**City of Aurora
Energy & Environment Division**

**Re: Denver Expansion Project - Scott City to DIA Pipeline
Magellan Midstream Partners, L.P. – Letter of Introduction
LOCATED IN SECTIONS 01, 12, 13, 14, 23, 26 AND 35 OF T3S, R65W, SECTION 36 OF
T2S, R65W AND SECTIONS 18, 19, 30 AND 31 OF T2S R64W OF THE SIXTH PRINCIPAL
MERIDIAN, CITY OF AURORA AND COUNTY OF ADAMS, STATE OF COLORADO**

Ref: Application No. ~~1831577~~

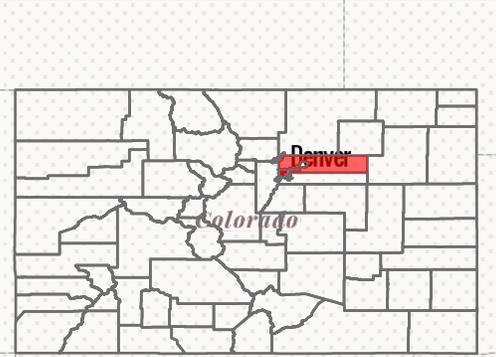
Please take a look at this map, although it is for City Council Wards, it provides clear City boundaries, not to be confused with Adams County, [City Council Wards | City of Aurora, Colorado](#). Also, please confirm that this is the most current map and route.
